ind Management Parameters for 10 Mb/s Operation and Associated Power Delivery over a Single Balance

Cl 147 SC 147.9.2 P 203 L 32 # i-1

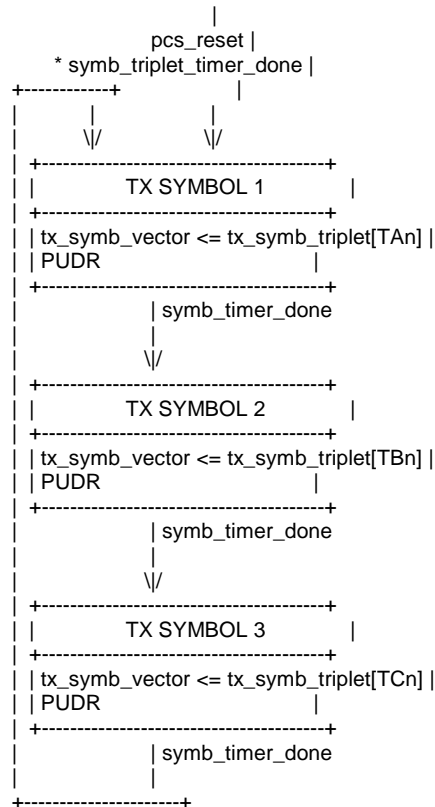
Cl 146 SC 146.3.3 P 117 L 18 # i-342  
 Law, David Hewlett Packard Enterprise  
 Comment Type TR Comment Status A State Diagram  
 Is it correct that 'The PCS Transmit function shall conform to the PCS Transmit state diagram in Figure 146-5 ...' and that 'In each symbol period, PCS Transmit generates a symbol An provided to the PMA ...'? The PCS Transmit state diagram in Figure 146-5 changes state based on STD being true, with STD being an alias for symb\_triplet\_timer\_done, and the output of the PCS Transmit state diagram is tx\_symb\_triplet which is defined in subclause 146.3.3.1.1 'Variables' as 'A triplet of ternary symbols generated by the PCS Transmit function after 4B3T encoding.'  
 I think the problem is that there is another function within the PCS Transmit function that is missing from the PCS Transmit state diagram in Figure 146-5, the 'multiplexor' shown in Figure 146-6 'PCS transmit symbol generation'. This 'multiplexor' function operates at the symbol clock rate and serialises the tx\_symb\_triplet code-groups output by the PCS Transmit state diagram into individual symbols.

This may also explain when subclause 146.3.3.1.3 'Timers' defines the symb\_timer that is not used in the PCS Transmit state diagram in Figure 146-5.  
 SuggestedRemedy  
 [1] Insert a new subclause 146.3.3.2 titled 'PCS Transmit multiplexor state diagram' that reads 'In each symbol period, the PCS Transmit multiplexor generates a ternary symbol that can take the values of {-1, 0, +1} and passes it to the PMA sublayer via the PMA\_UNITDATA.request primitive. The nominal symbol clock frequency is specified in 146.5.4.5.'. Renumber the following subclauses as required.  
 [2] Add a new subclause 146.3.3.2.1 titled 'Variables' that reads:  
 pcs\_reset  
 The pcs\_reset parameter set by the PCS Reset function.  
 Values: TRUE or FALSE  
 tx\_symb\_vector  
 A ternary symbol generated through serialization of tx\_symb\_triplet. This symbol is conveyed to the PMA as the parameter of a PMA\_UNITDATA.request(tx\_symb\_vector) service primitive.

[6] Insert a new Figure 145-6 shown below (view using a non-proportional font such as courier), renumbering the following figures as required.

[7] Add text to subclause 146.3.3 'PCS Transmit' that reads 'The PCS Transmit function shall conform to the PCS Transmit state diagram in in Figure 146-5 and the PCS Transmit multiplexor state diagram in 146-6, and their associated state variables, functions, timers, and messages.'
